**CONTRACT NO. T-668A, CAPITAL PROJECT 0301A
THE SCUDDER FALLS BRIDGE REPLACEMENT PROJECT**

ADDENDUM NO. 9

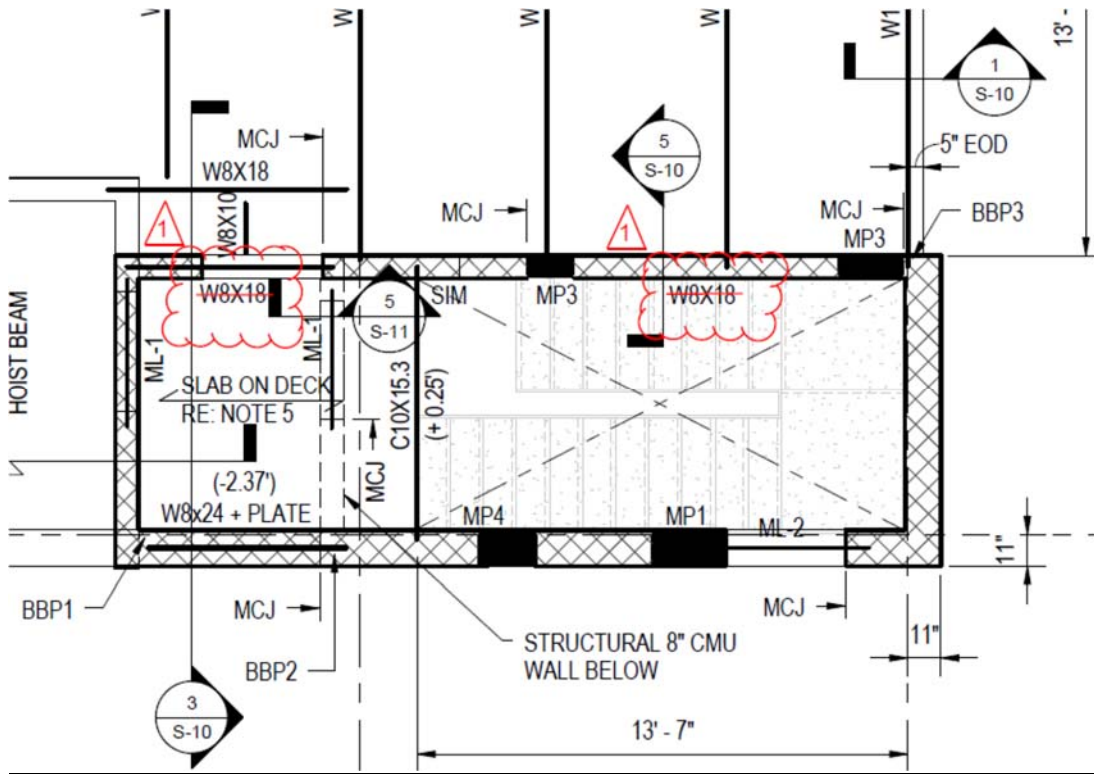
1. On Sheet S-7 of S-19 in Package C, remove the W8X18 notations that is indicated in two (2) places as shown below.
